RE: PETITION NO. 1184 - Beacon Falls Energy Park, LLC petition for a declaratory ruling that no Certificate of Environmental Compatibility and Public Need is required for the proposed construction, operation, and maintenance of a 63.3 Megawatt AC fuel cell facility located on Lopus Road, Beacon Falls, Connecticut.

Petition 1184
Beacon Falls Energy Park (BFEP)
Development and Management Plan Interrogatories

DEVELOPMENT AND MANAGEMENT (D&M) PLAN

DJK DESIGNED	DJL DRAWN	SRD CHECKED
N.T.S.		
SCALE		
DATE OCTOBER 7, 2016		
PROJECT NO. 1103-87		
SD-1		
SHEET NAME

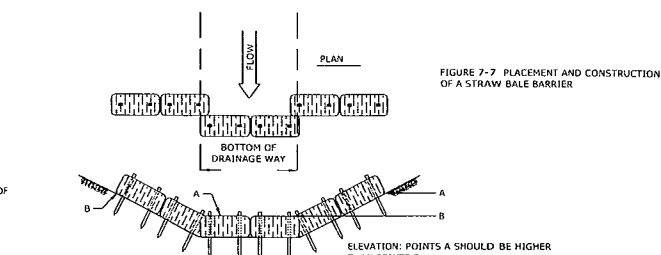
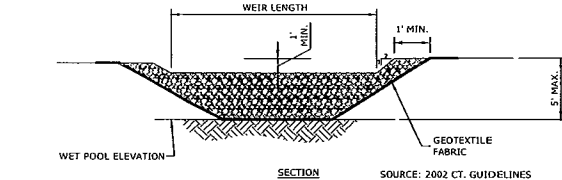
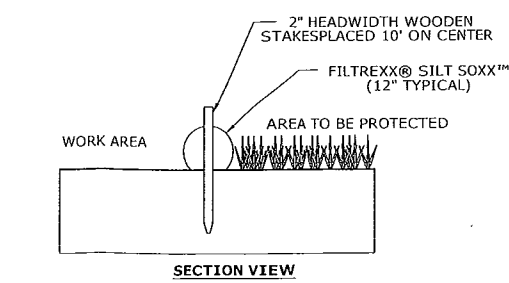
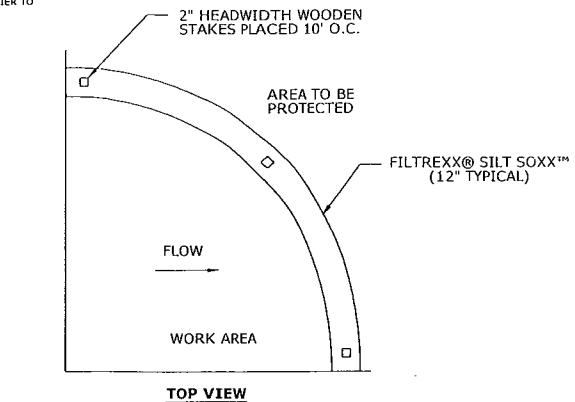
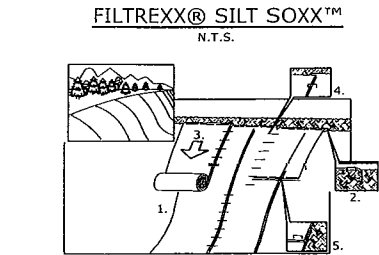
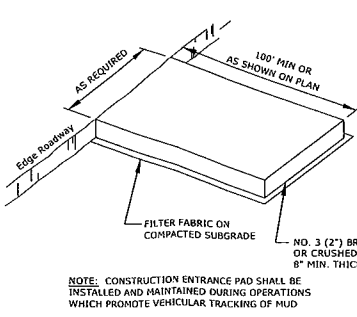
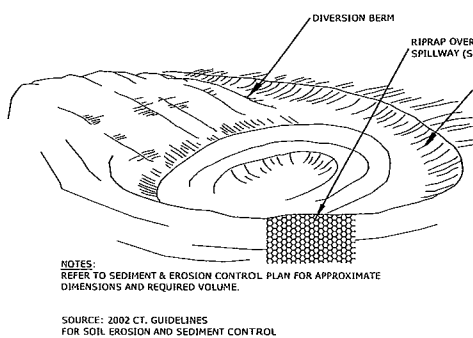
5. On page 7 of the D&M Plan narrative, it states temporary vegetative cover will be established on all unprotected areas that produce sediment where the estimated period of bare soil is less than 12 months. This statement should be modified to state "where the estimated period of bare soil is less than 30 days".

6. On page 7 of the D&M Plan narrative, it states erosion control blankets would be installed on critical slopes. Please define critical slopes. Modify Sheet SE and SD-1 to include locations of critical slopes and related erosion control blanket specifications. Can 100 percent natural fiber erosion blankets be used in these areas?

8. Referring to Sheet SD-1, a table is given showing frequency of erosion and sediment control inspections. Please explain why erosion and sediment control measures are not checked after each rain event.

9. Can coir rolls or silt socks be used as erosion and sediment control measures at the south end of the construction area to provide additional protection to the adjacent pond?

10. Sheet SD-1 shows detail for a “diversion berm and swale”. In what areas would this feature be used?

11. Sheet SD-1 shows detail for a “riprap lined drainage swale”. In what areas would this feature be used? When would the grade of the swale side slopes be determined and under what factors? Would the swale be able to support vegetation? Would erosion control blankets on the outer surface be required for swale slopes greater than 3:1?

RESPONSE: The D&M Plan narrative has been modified. The text on revised Sheet SD-1 of the plans has also been modified accordingly.

RESPONSE: The critical slopes are denoted on Plan SE where the Erosion Control Blanket (ECB) is specified. For this project, the critical slope is defined as the 2:1 fill embankment east of the access driveway. An organic biodegradable ECB has been specified on the plans (North American Green Rollmax S150BN or approved equal). Revised Sheets SE and SD-1 depict this modification. ECB has also been added to a portion of slope on the north side of Lopus Road.

RESPONSE: The standard set forth for inspection of sediment and erosion control measures in the 2002 Connecticut Guidelines for Soil Erosion and Sediment Control is at least once a week and within 24 hours of the end of a storm with a rainfall amount of 0.5 inch or greater. This is what is specified for the project.

RESPONSE: A silt sock has been added to the revised SE and SD-1 sheets.

RESPONSE: The diversion berm/swale (DB) is depicted on Sheet SE, on the eastern side of the site to control site construction phase runoff away from the railroad right of way.

RESPONSE: The details on Sheet SD-1 for Temporary Sediment Trap and Sediment Trap Riprap Overflow Spillway are intended for use in the temporary sediment traps depicted on Sheet SE. The Riprap Lined Drainage Swale detail on Sheet SD-2 is to be utilized in the locations depicted on Sheets GU-1, GU-2, and GU-3 and functions to convey runoff into or out of the stormwater and water treatment wastewater infiltration basins. The slopes of the

ELECTRICAL
SITE LIGHTING AND
SECURITY CAMERA PLAN

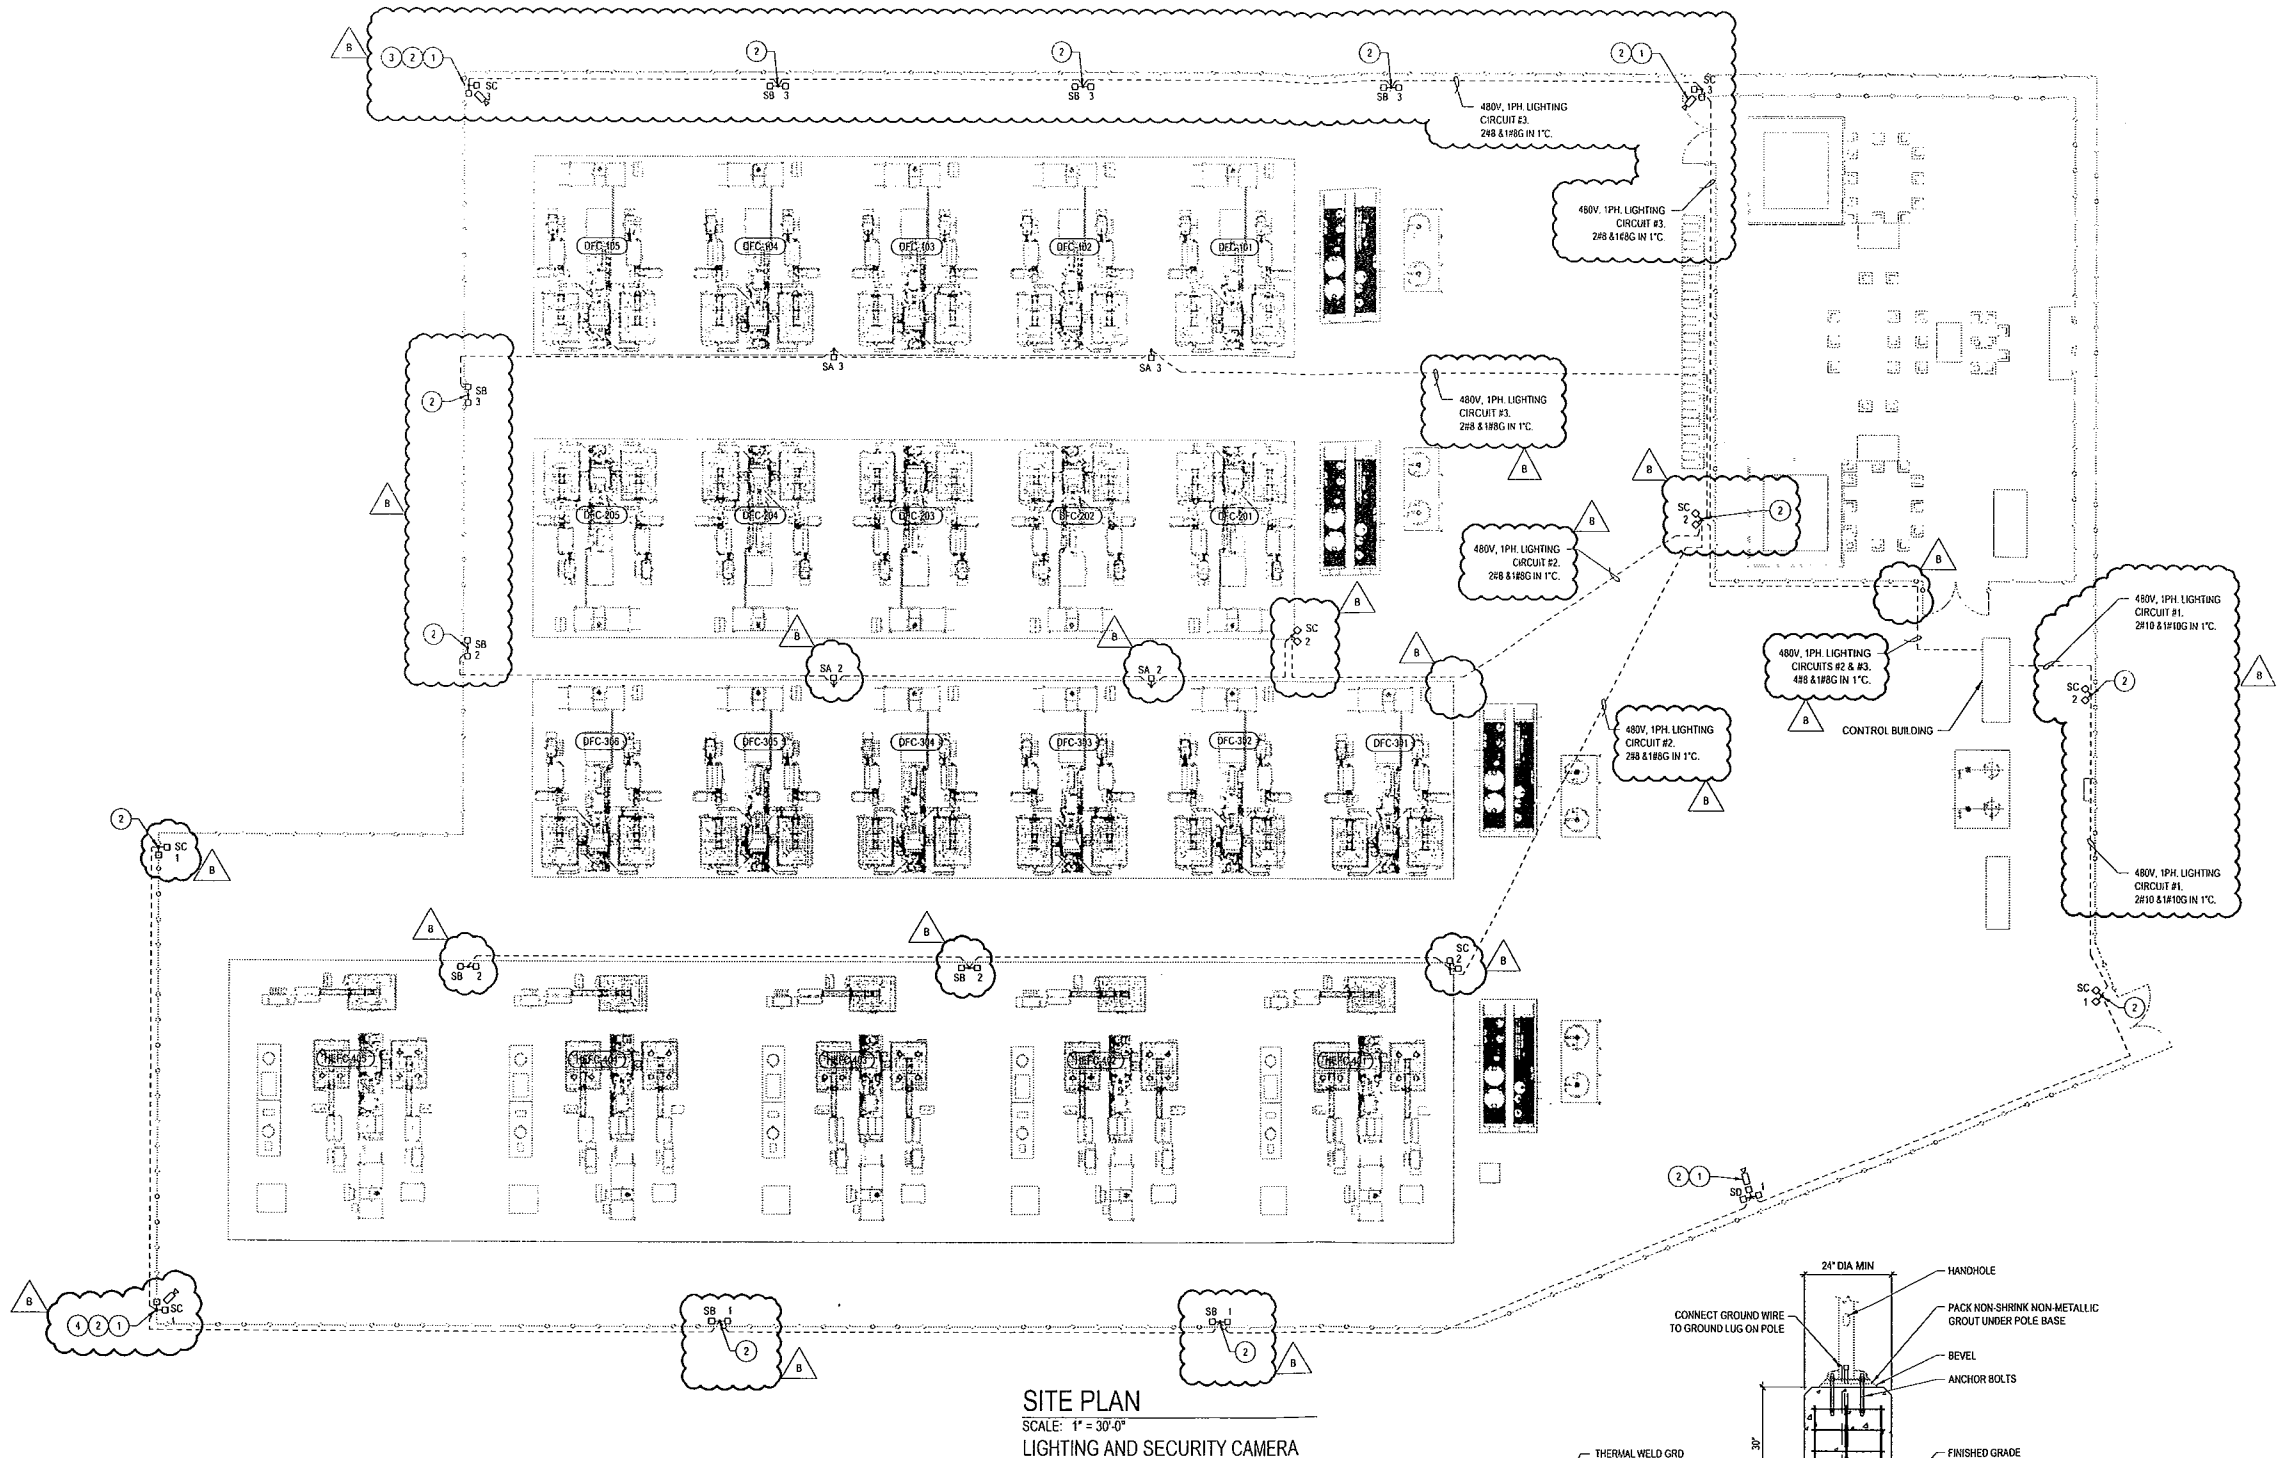
16. Is exterior lighting proposed for the facility? If so, submit an exterior lighting plan, including identification of lights operated continuously and as necessary.

RESPONSE: Exterior lighting is proposed for the facility for security and safety. Please see drawing E-133 for the location and types of fixtures. All exterior lights will be controlled to be on at night. All fixtures will be Dark Sky compliant.
